Subject: Dixon House CC18727  
Type II Variance from Stormwater Drainage Manual

**DIXON HOUSE  
STORM CC18727  
GALLOWAY ROAD  
COLUMBUS, OHIO**

**STORMWATER DRAINAGE MANUAL  
TYPE II VARIANCE APPLICATION**

PROJECT TITLE:			
DETENTION BASIN VARIANCE FOR DIXON HOUSE PREFERRED DEVELOPMENT ALTERNATIVE			
DIVISION USE ONLY		OWNER	
		CONTRACTOR	
		INSPECTOR	
AGREEMENT	COMPLETED		
RPD	CKD	CID	CON.DR.
INDEX DETAIL	RECORD FILE

PROP. EXTENDED WET RETENTION POND TYPICAL SECTION  
(NO SCALE)

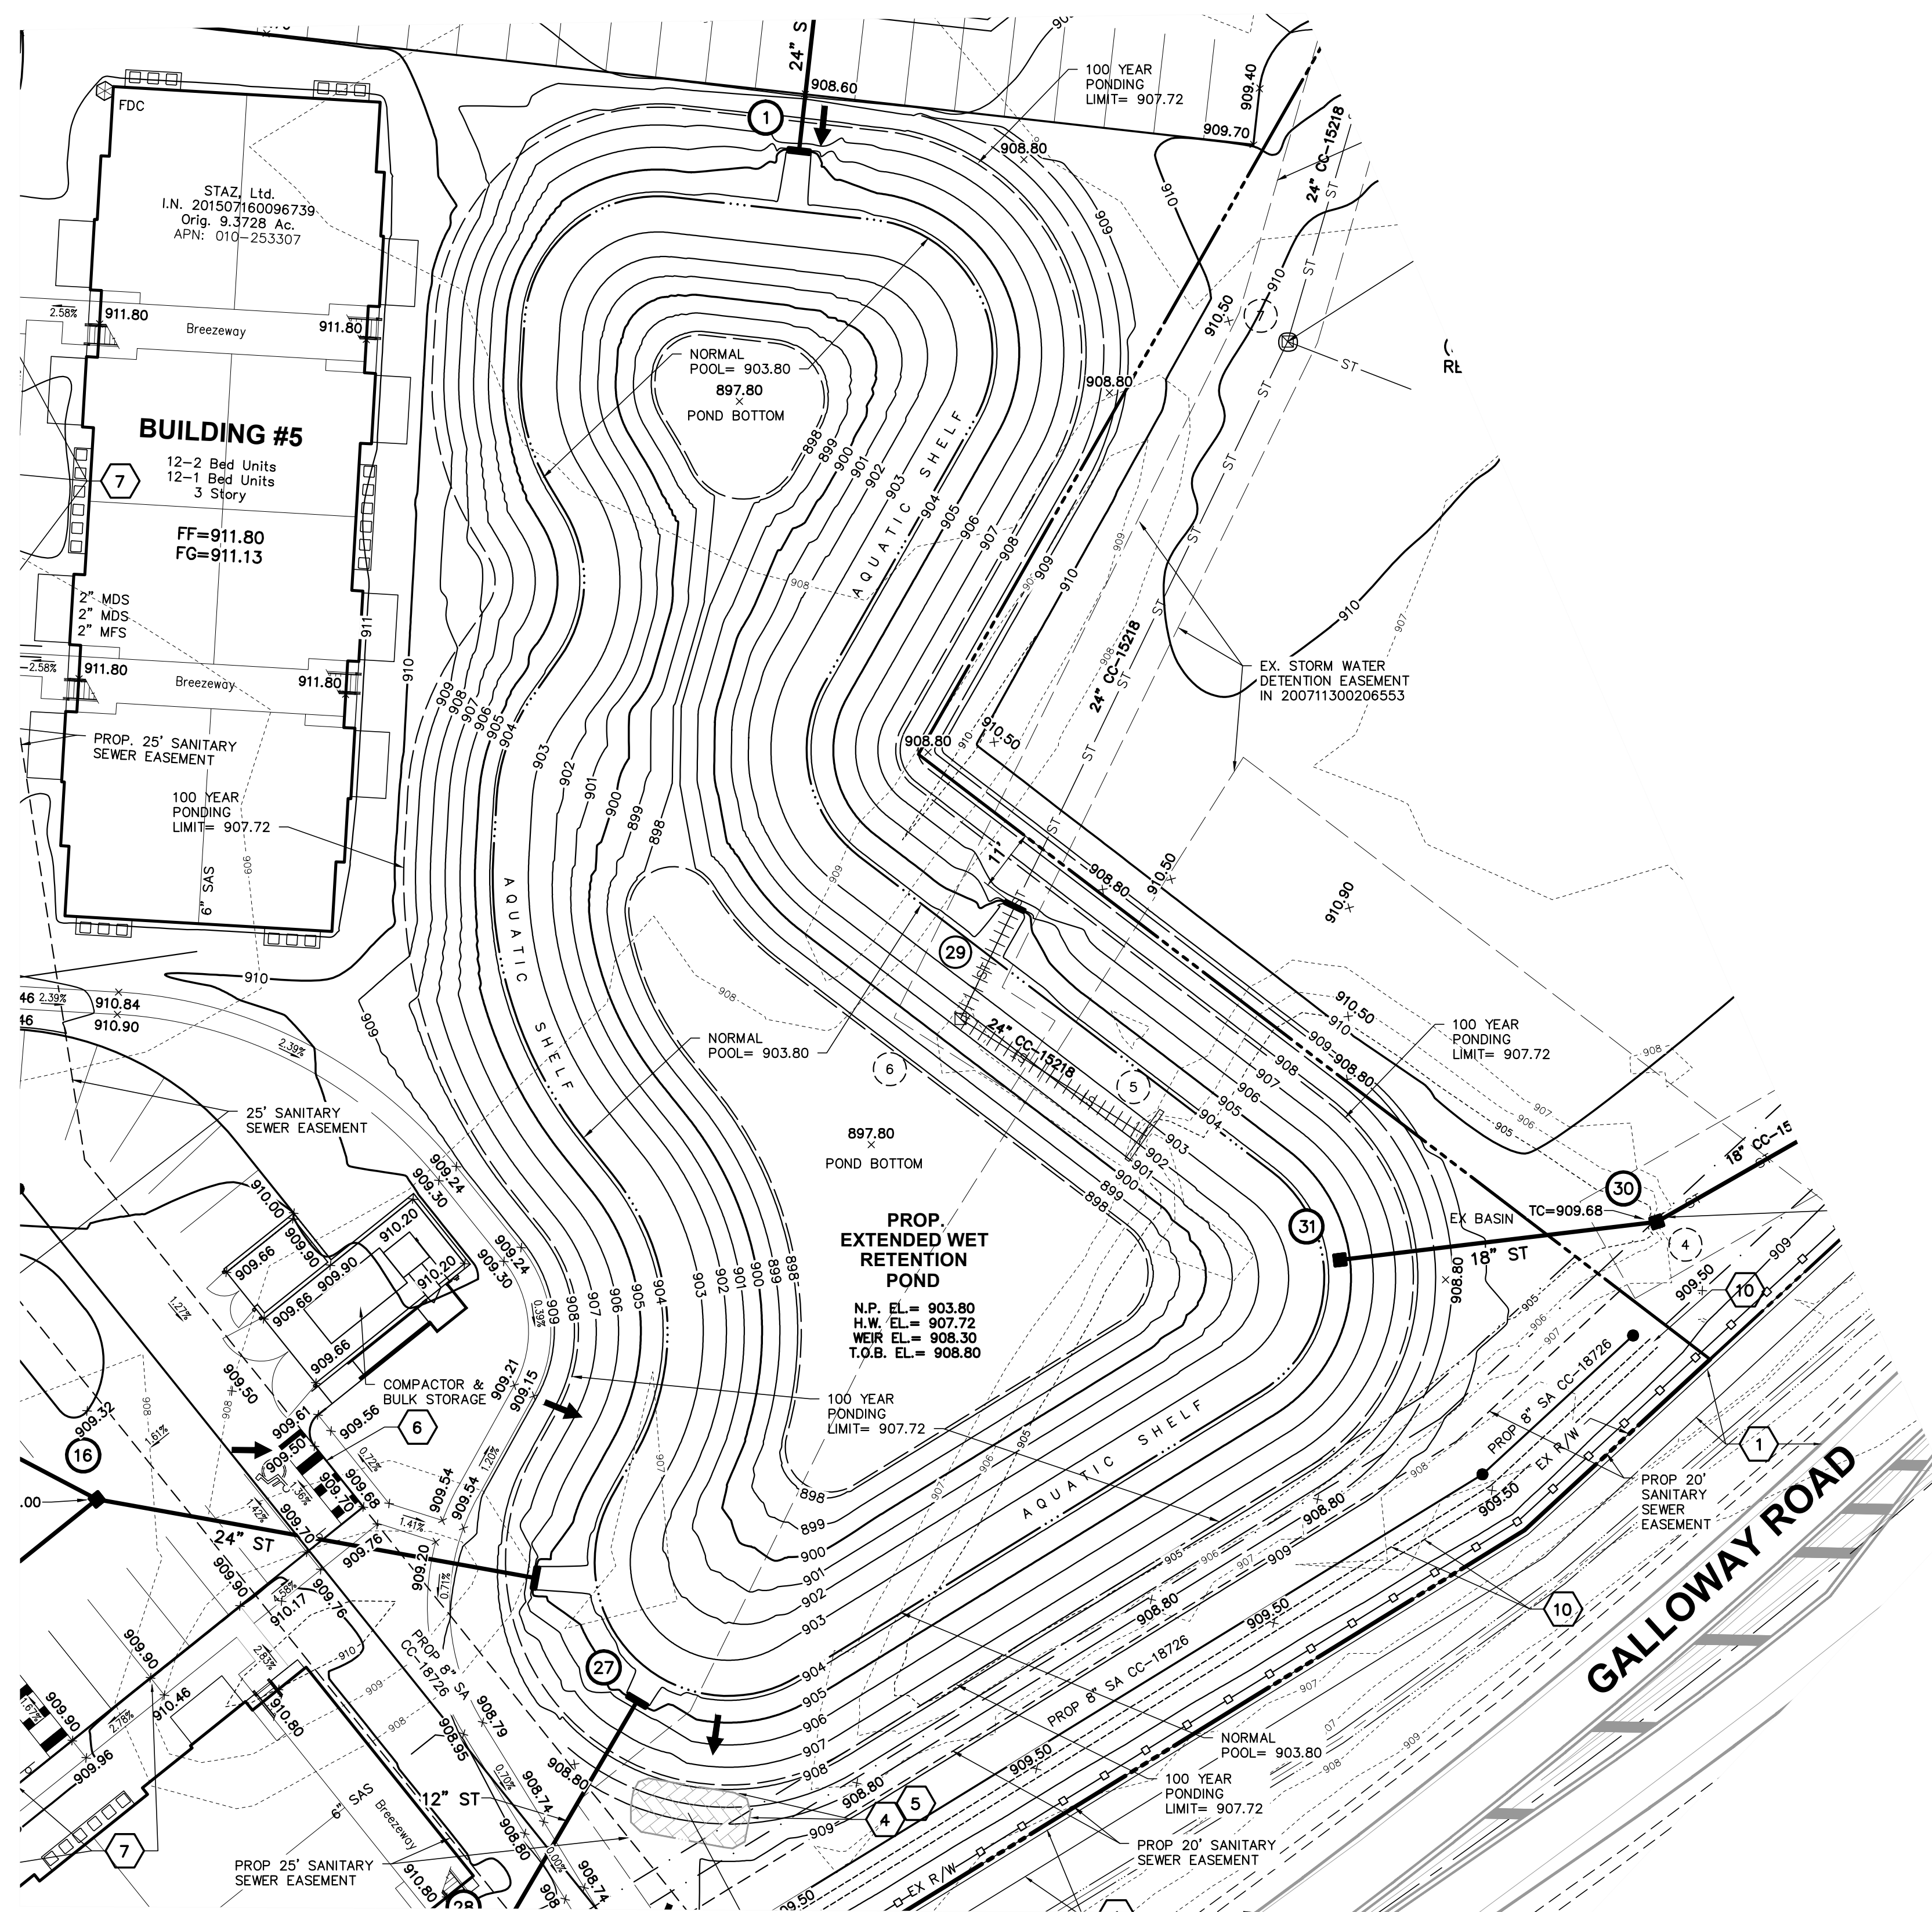
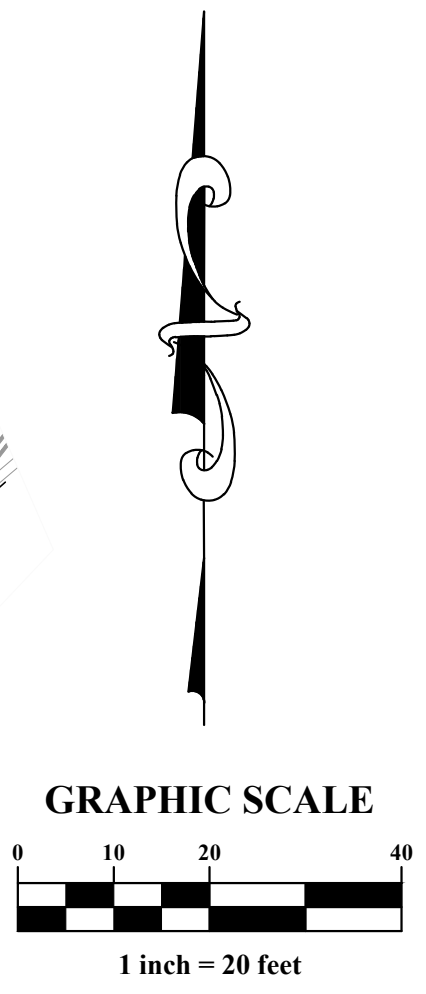
Under full compliance the retaining wall would be removed, and the proposed wet pond slopes established per the approved storm and grading plan CC18727. Under this option the pond would need partially drained and sediment control installed at the outlet structure for the duration of the regrading work. The results of this alternative are financially detrimental due to the loss involved with the cost for the wall installation and subsequent removal. Additionally, the desired post-construction access for building maintenance would no longer be available. Please refer to the full compliance exhibit in the appendix.

SECTION A-A  
TYPICAL AS-BUILT WET BASIN SECTION AT EXISTING RETAINING WALL  
NO SCALE

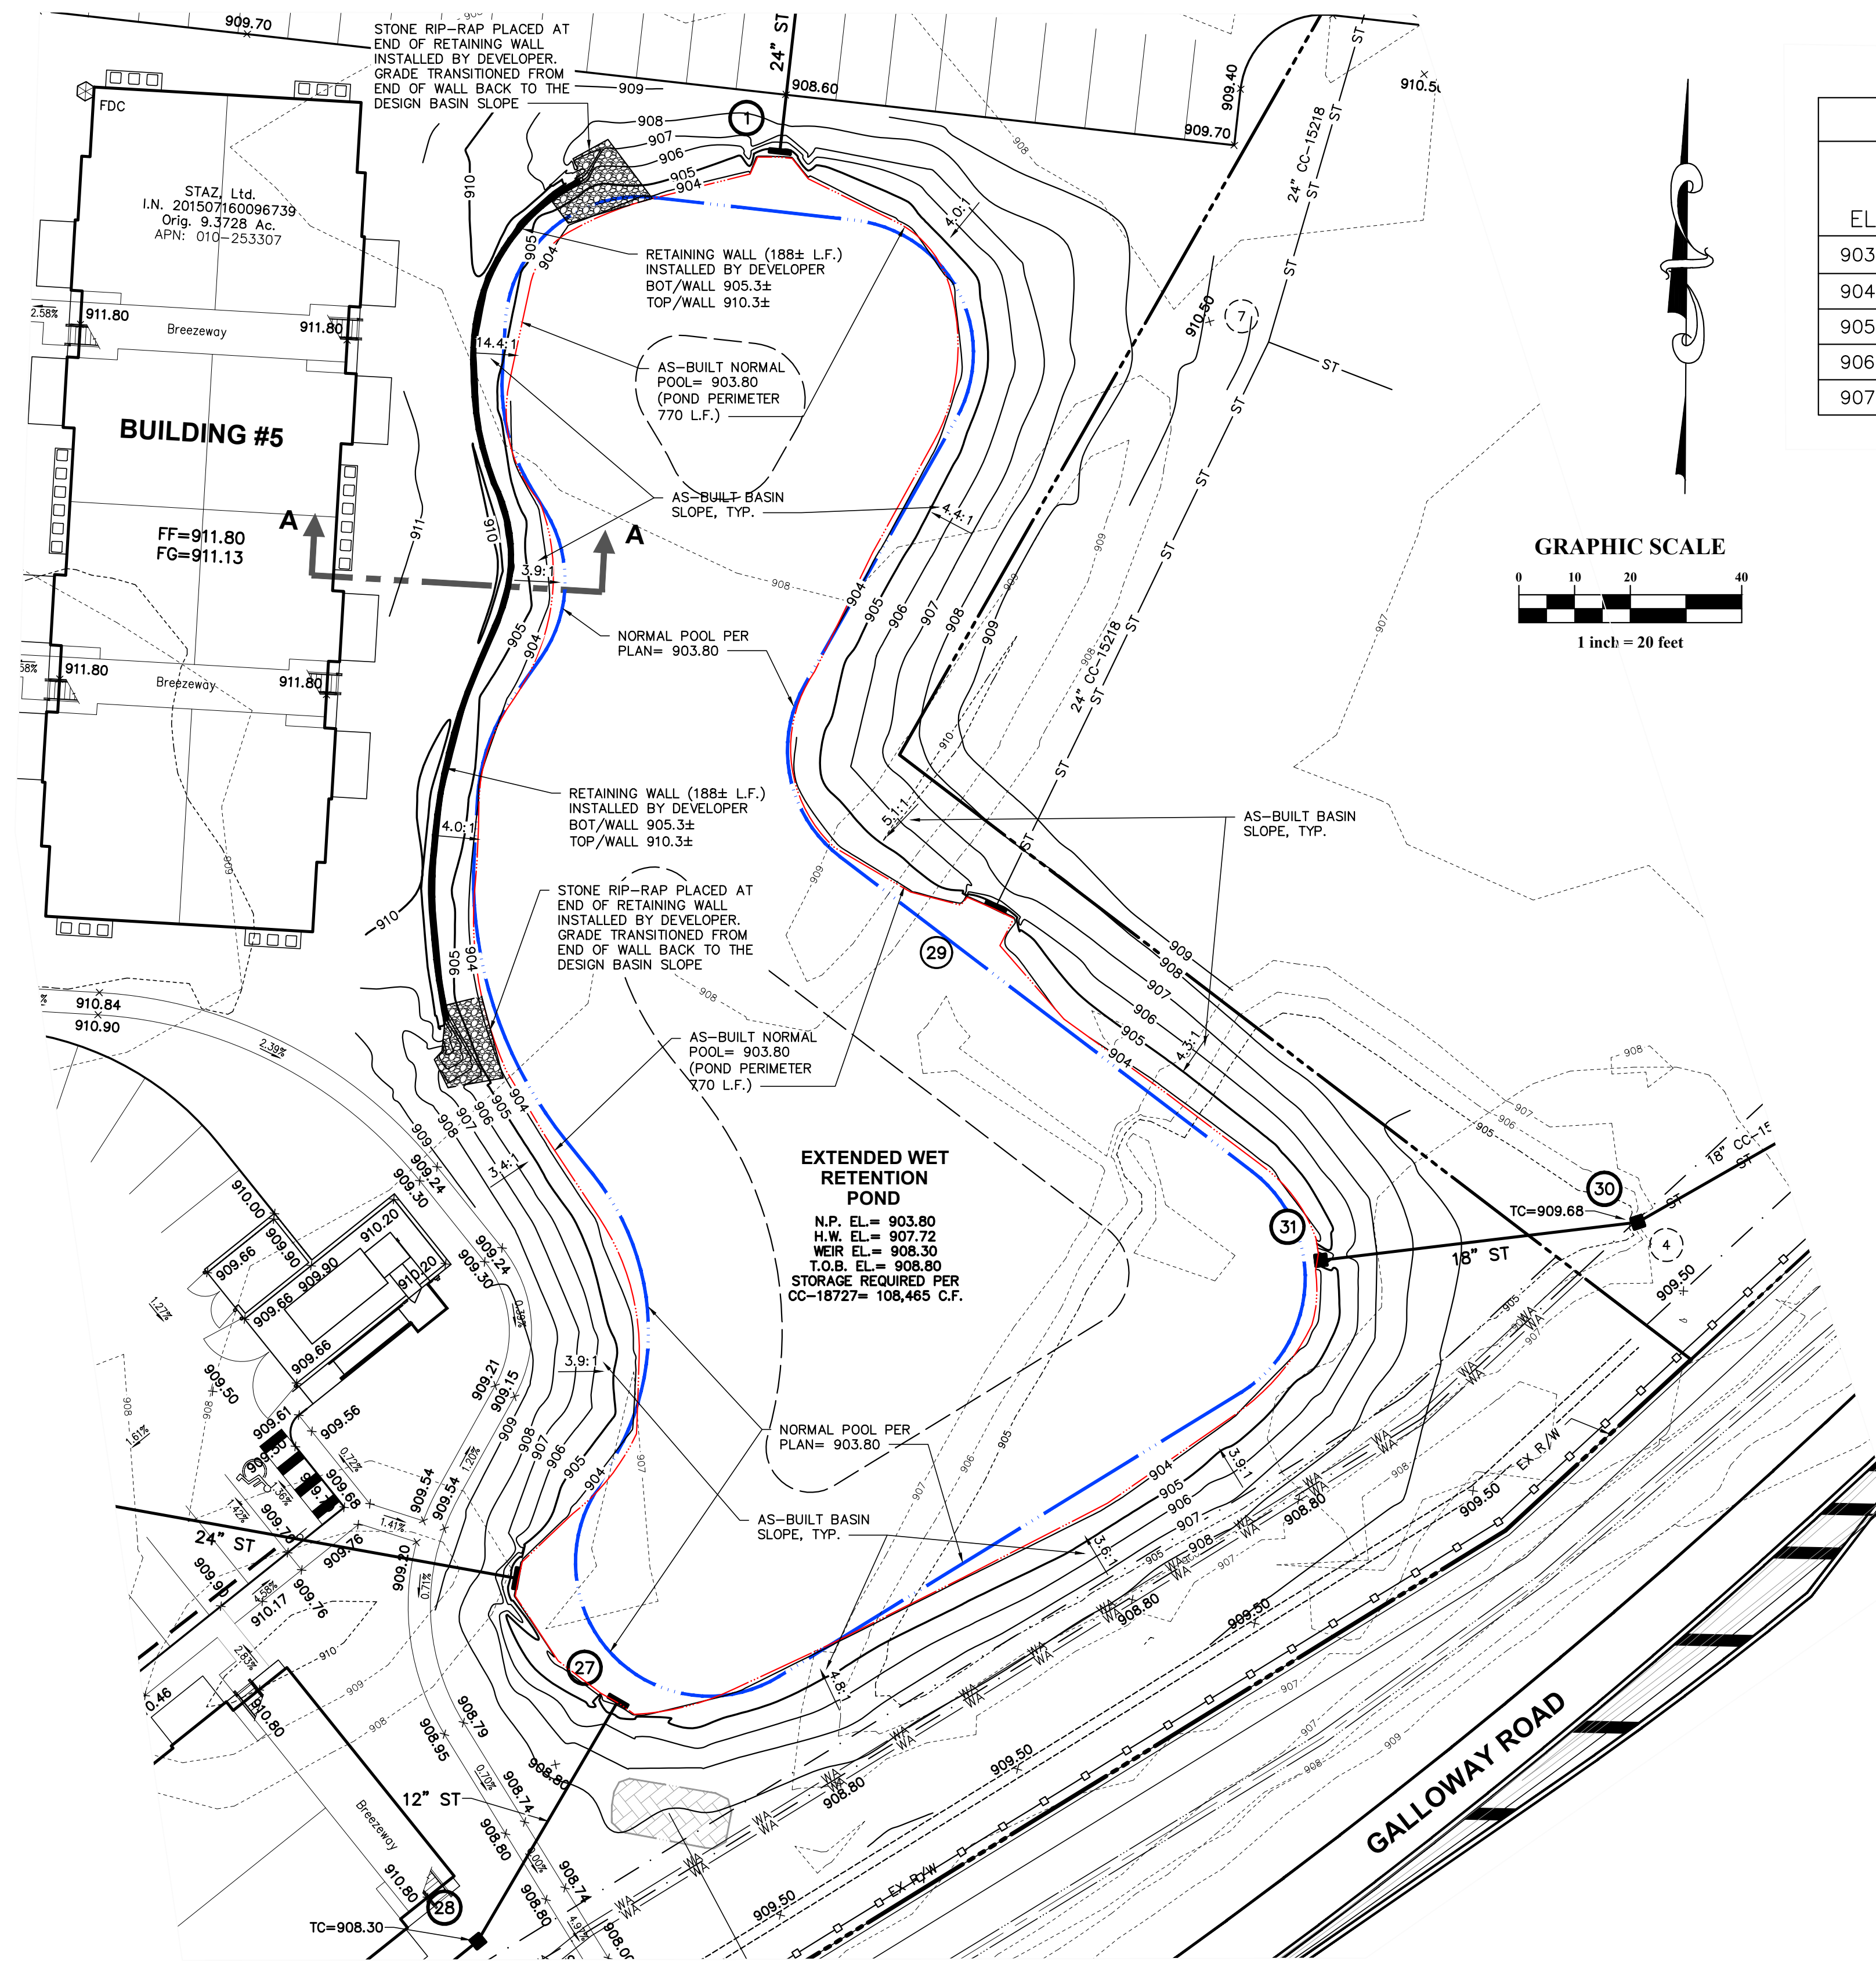
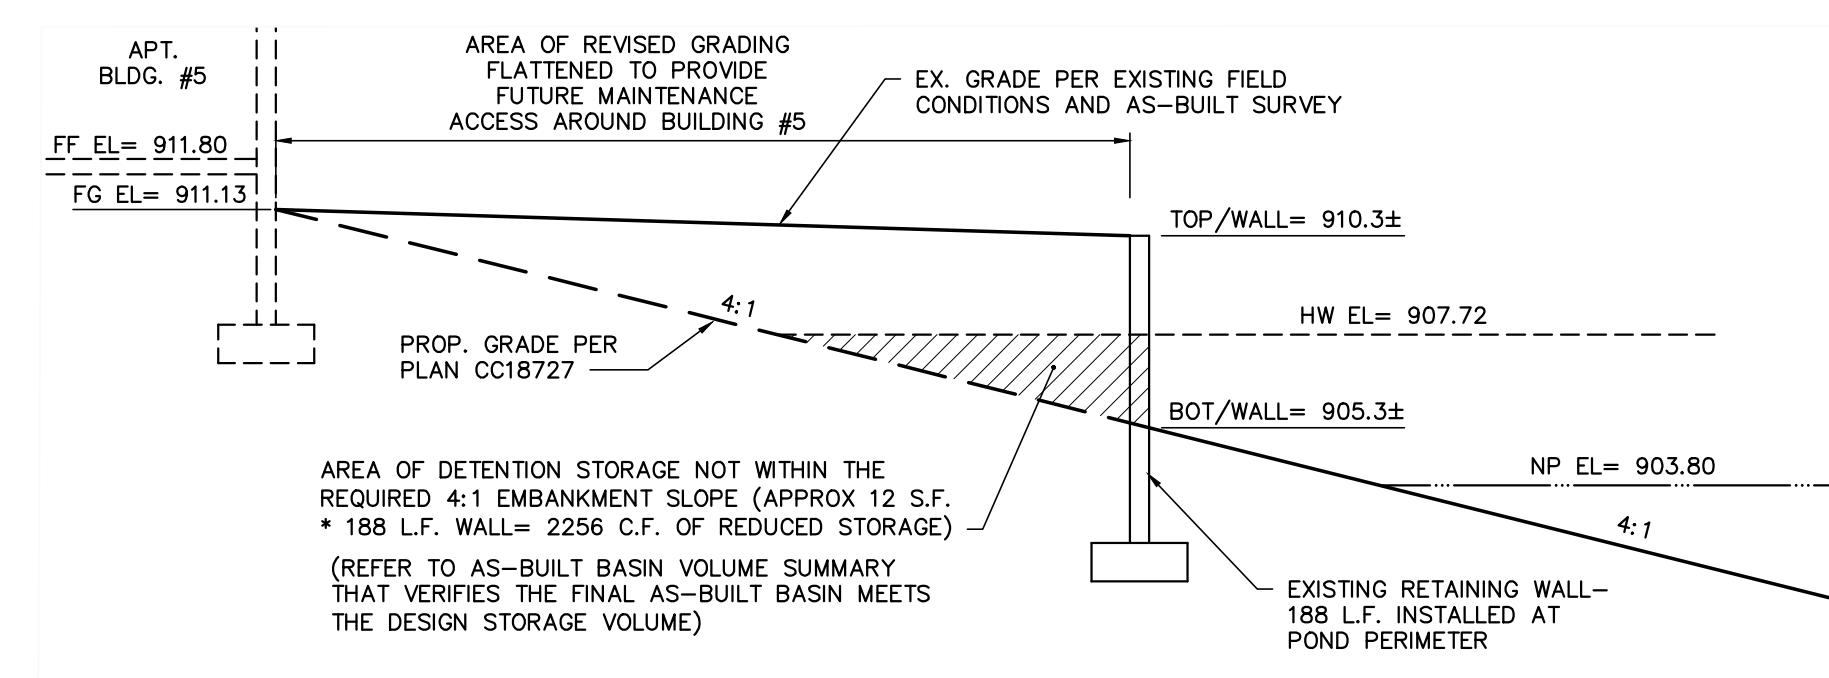
REVISIONS		
NO.	DESCRIPTION	APPROVAL/DATE
1	ADDED SHEET 9A: A RETAINING WALL AND AREAS OF RIP-RAP WERE ADDED AND NOT PART OF THE APPROVED PLAN FOR THE POND. AS-BUILT SURVEY VERIFIES THE REQUIRED DETENTION STORAGE VOLUME IS MAINTAINED; NO OUTLET DESIGN CHANGES ARE REQUIRED.
